**CITY OF TEMPE
BOARD OF ADJUSTMENT**

**Meeting Date: 11/15/2017
Agenda Item: 3**

ACTION: Request to appeal the Hearing Officer’s decision of October 3, 2017 to approve a variance to reduce the required landscape buffer from the street sidewalk for a maneuvering drive lane from 20 feet (20’) to 11 feet 8 inches (11’-8”) for QUICK QUACK CAR WASH, located at 5201 South McClintock Drive. The appellants are Rose Law Group, PC.

DEVELOPMENT PROJECT FILE
for
QUICK QUACK CAR WASH
(PL170240)

EXHIBIT E

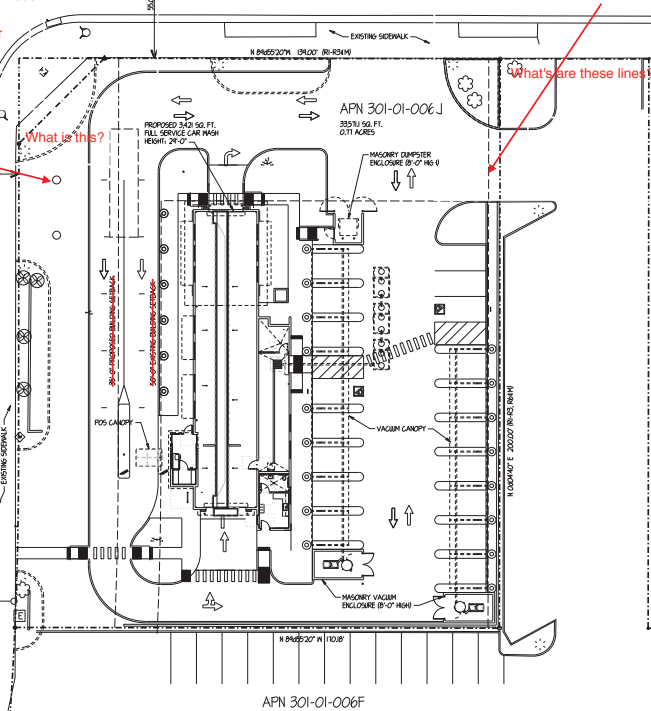
- Provide complete data in project data table. See DPR application p. 2.
- PCC-1 setbacks are 0' front (north), 0' street side (west), 30' interior side (east), and 30' rear (south).

- 20' parking and drive-through landscape setback is required along both streets. See ZDC Table 4-203A and Sec. 3-408.
- Remove all landscape symbols from site plan.

- Do not show walls, curb, and landscaping that exists but will not remain with construction.
- Dimension proposed building setbacks (from north, south, west, and east) from property lines. Do not show required setback lines. Only dimension the proposed.

- Provide screen walls entire length of property, along parking and maneuvering areas. Stagger walls. Provide wall elevations, noting height, materials, and colors.

- Use the standard symbol for property lines, a solid line followed by two dashed lines.
- Per ZDC Sec. 4-704.A.1., provide landscape islands on both north and south ends of parking rows, between spaces and vacuum enclosures.

- Provide a min. 10% landscaping of surface area of surface parking lot and note the % required and provided in the data table. Alternatively, you may submit a "development plan shadow study", per ZDC Sec. 4-704.A.2.

- Show existing (to remain) and proposed street and sidewalk improvements, dimensioned to centerline of the streets. Sidewalks along both streets shall be min. 8' wide.

- Identify adjacent land use types and zoning districts.
- Identify all driveways and fire hydrants within 125' radius of the site.
- Will the site have any vending machines? If so, show proposed location(s).

- Per Building Safety comment, canopies must be min. 5' from property lines and proposed car wash building.
- Per Solid Waste Division, provide a separate solid waste plan, per DS-116, that includes a recycle bin. Provide a 45' clear backing distance from face of enclosure gates to back of sidewalk on Baseline.

- Provide upgraded paving at driveway consisting of integral colored unit paving. Extend paving in the driveway from the ROW line for a min. distance of 20' on-site from curb to curb.

Provide a 20' landscape buffer along north property line. No vehicle maneuvering is permitted within this buffer.

What's this 'triangular area'?

Label

What is this?

What are these lines?

Verify cross access easement with property to east.

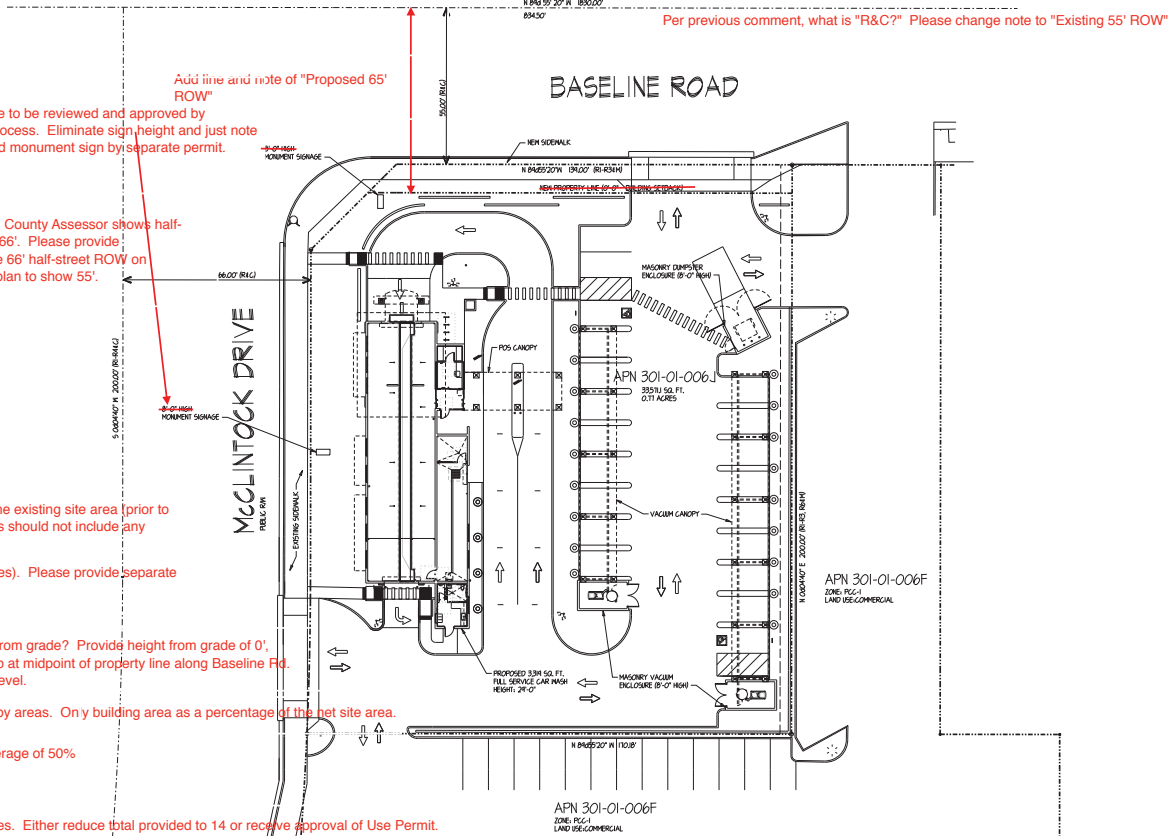
Note min. LS % of 15%

Note all the required building setbacks.

Note max lot coverage of 50%

Delete ratio. Min. 4 required.

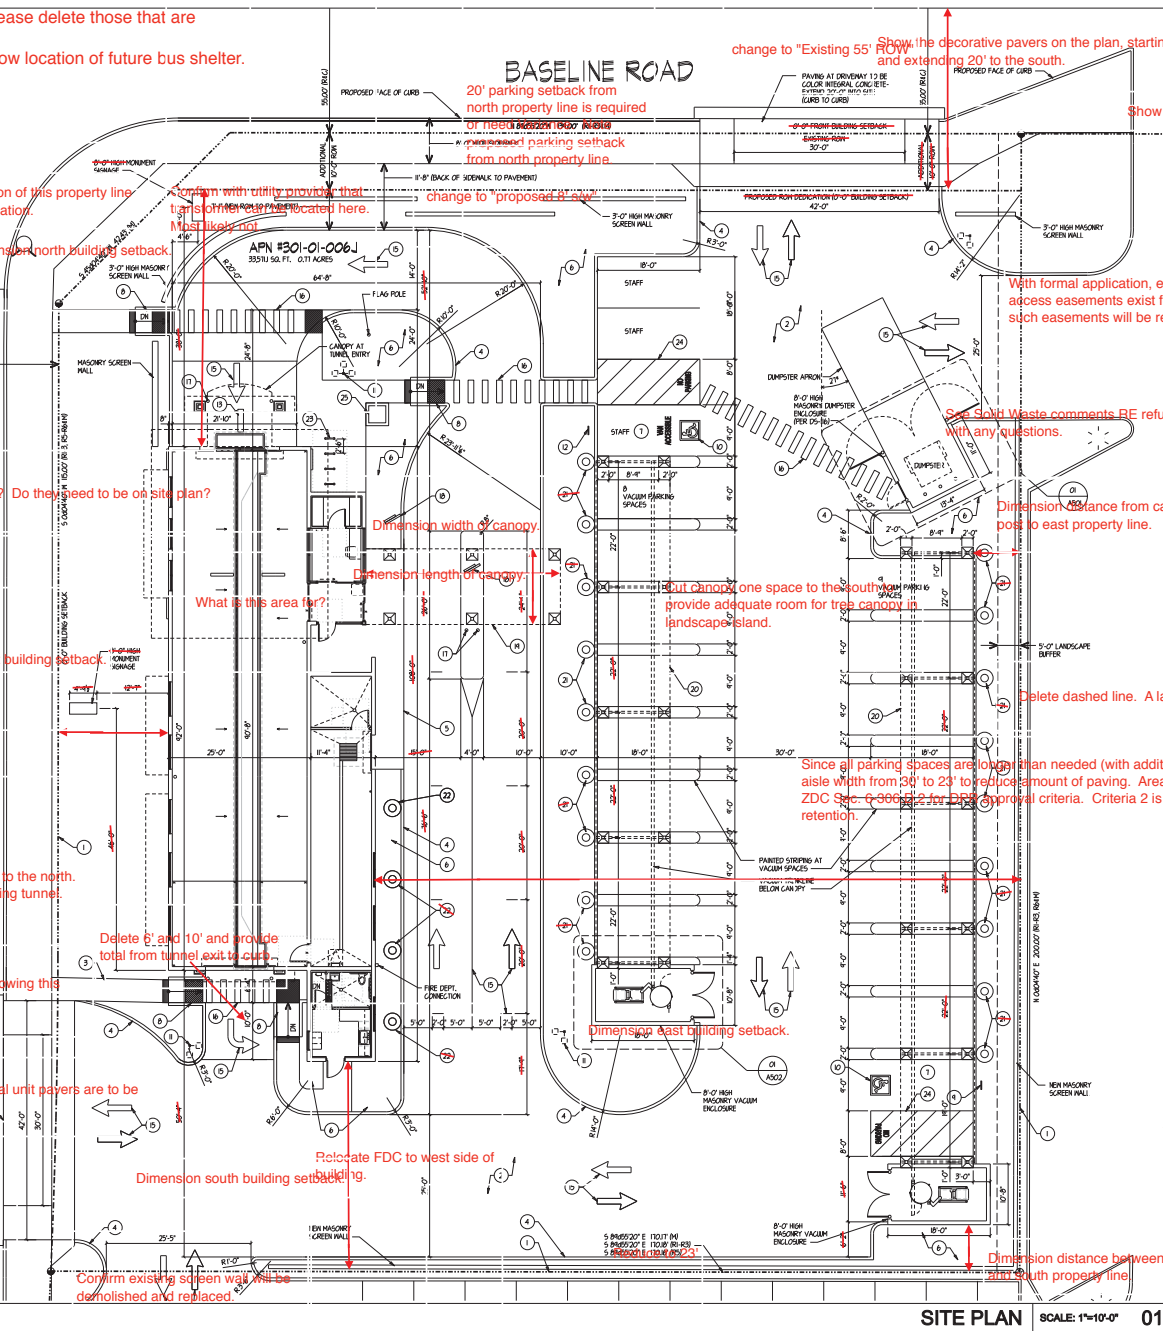
What do arrows refer to? Do they need to be on site plan?

Eliminate walkway since one is provided to the north. This one would conflict with vehicles exiting tunnel.
